Re: Addendum No. 2
Colleen Drive Part 2 Storm Improvements
Boardman Township, Ohio

Date: June 24, 2026

PROJECT NO:	
242438	
DRAWING NAME	
C-12	
SHEET	OF
12	13

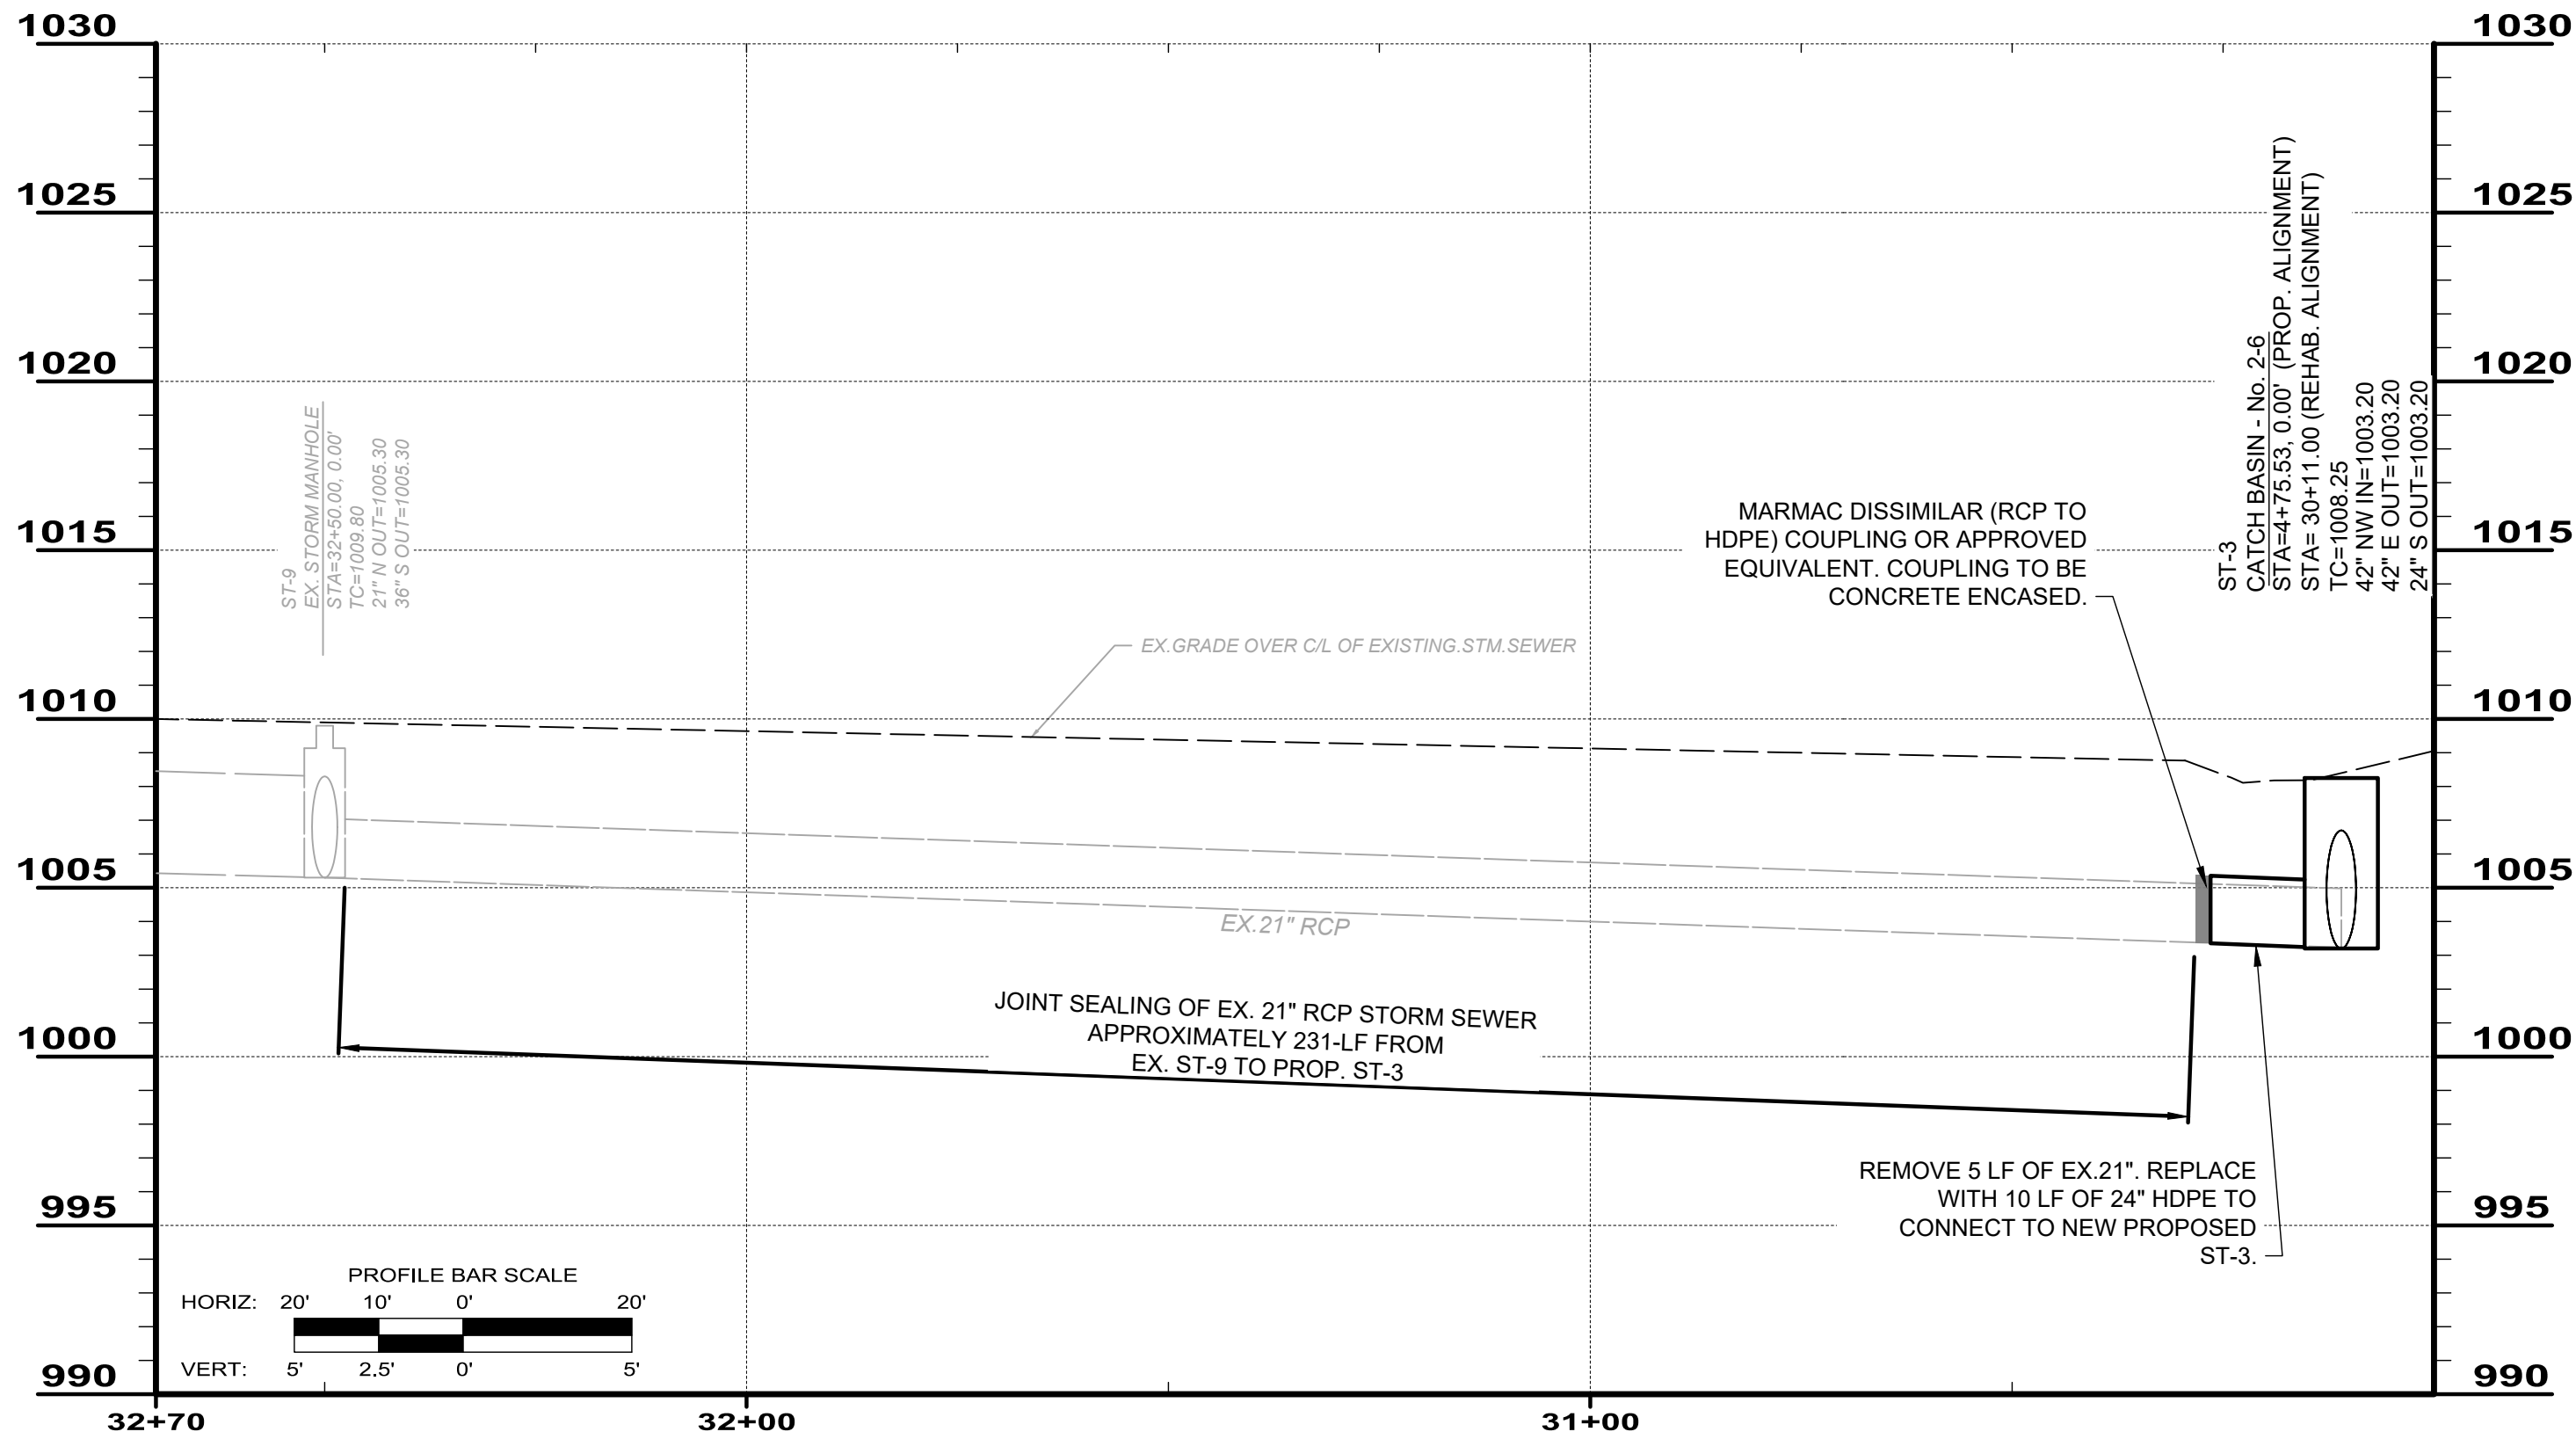
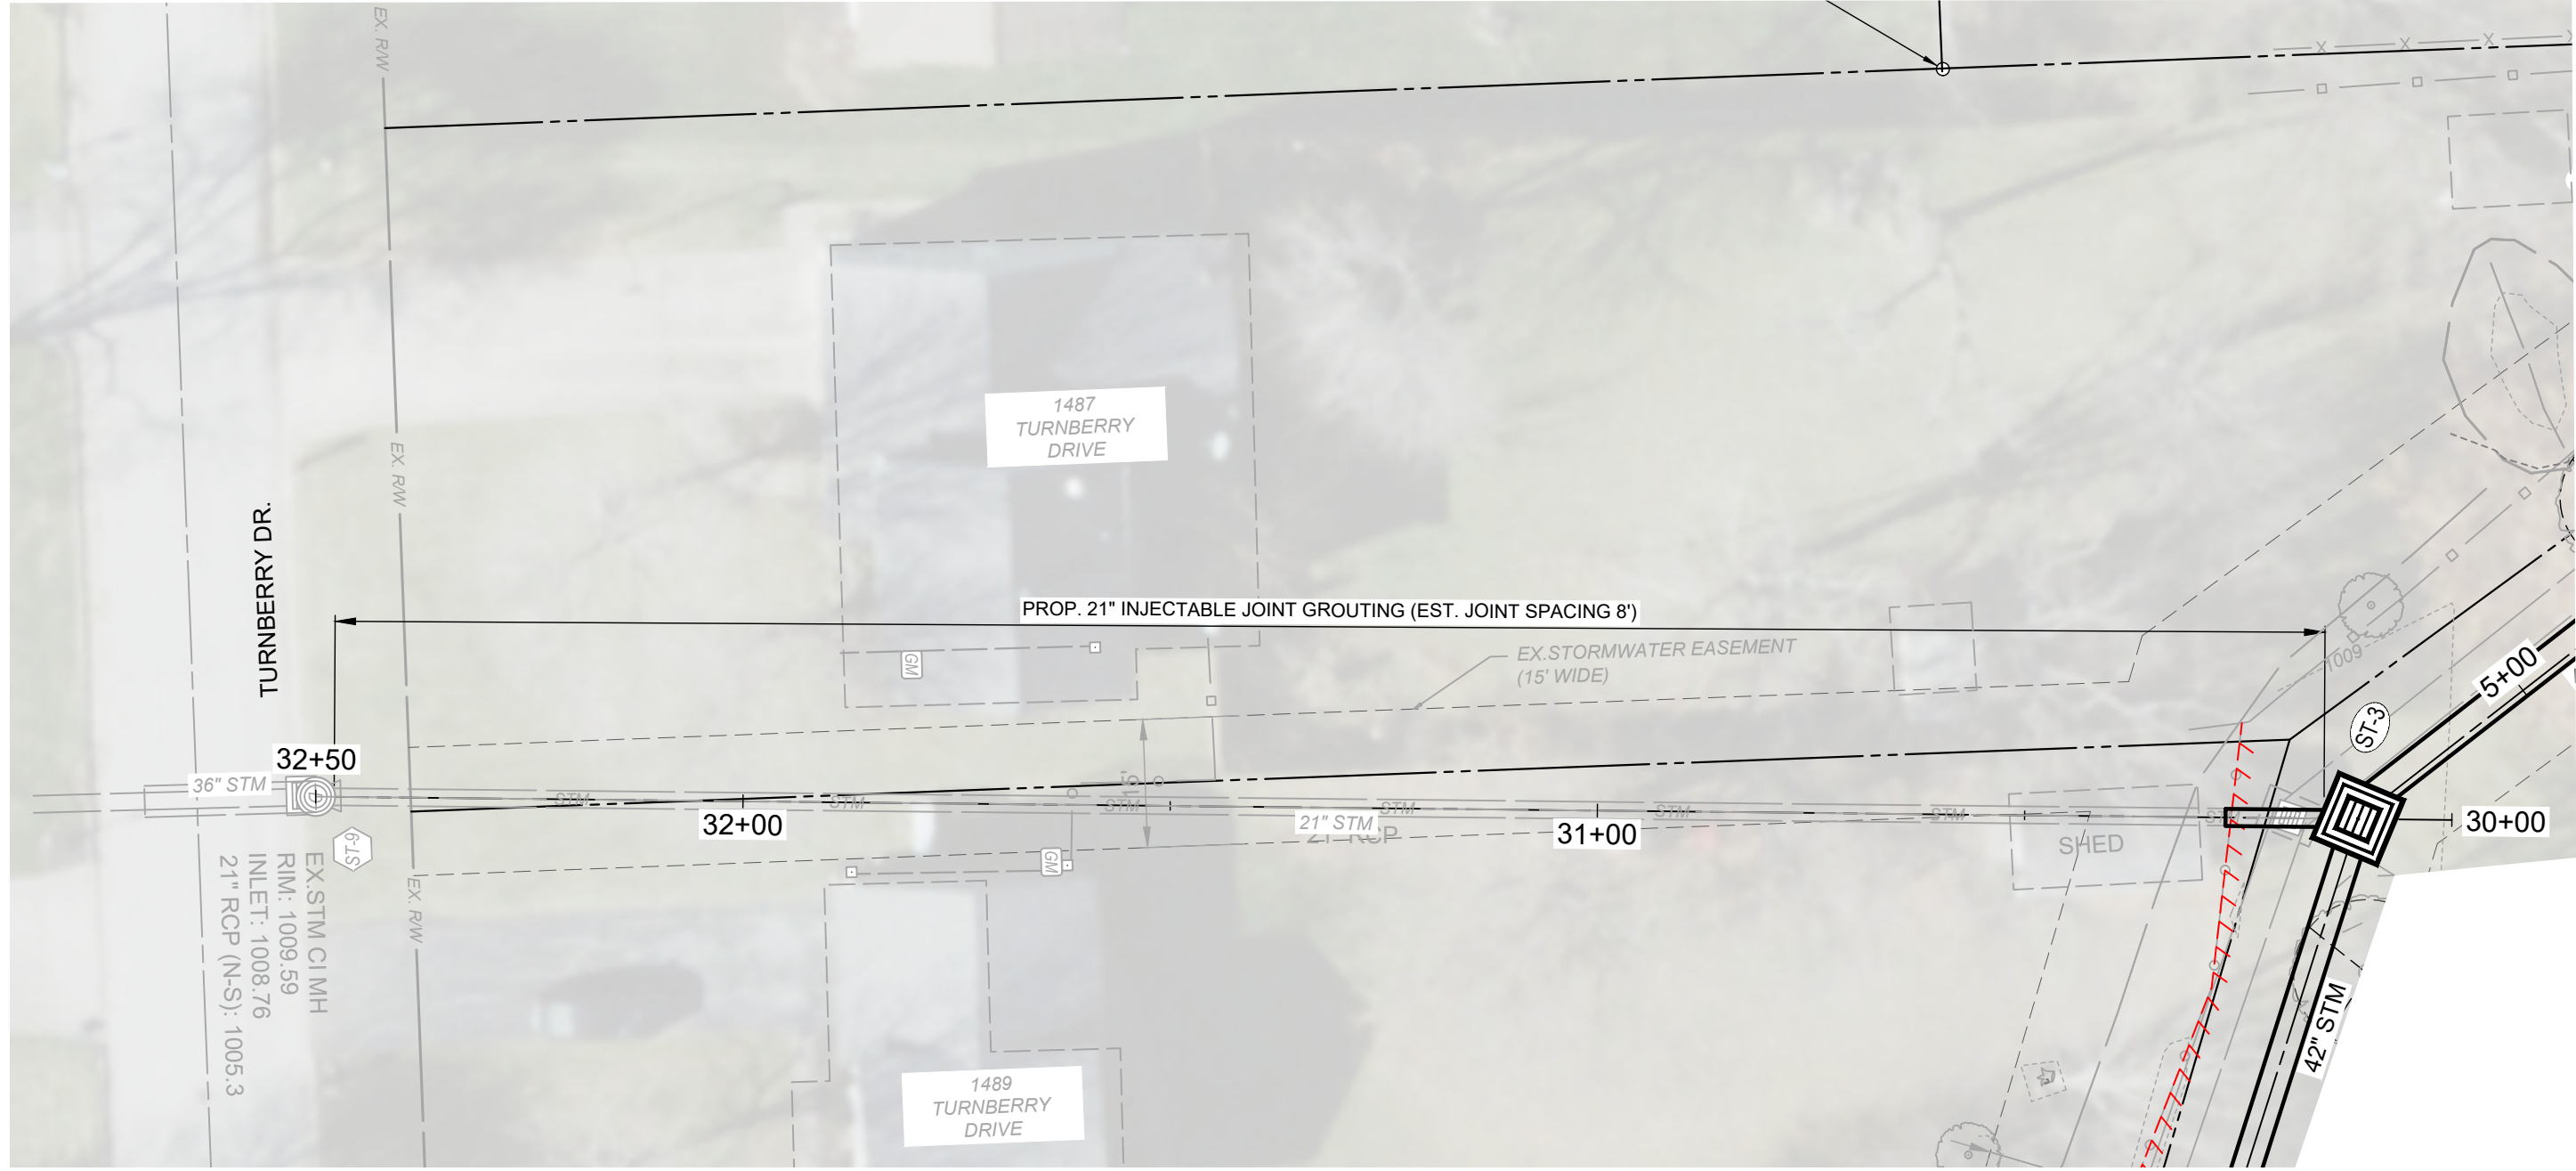
Q5. On Sheet 12, a 21" HDPE pipe is specified, but this size is not available in HDPE. Should RCP be used instead?

A5. No, we have revised the plans to use a 24" HDPE pipe and include a note requiring concrete encasement at the coupling.

Replace plan sheet 12/13 from Addendum 1 with the enclosed revised plan sheet 12/13
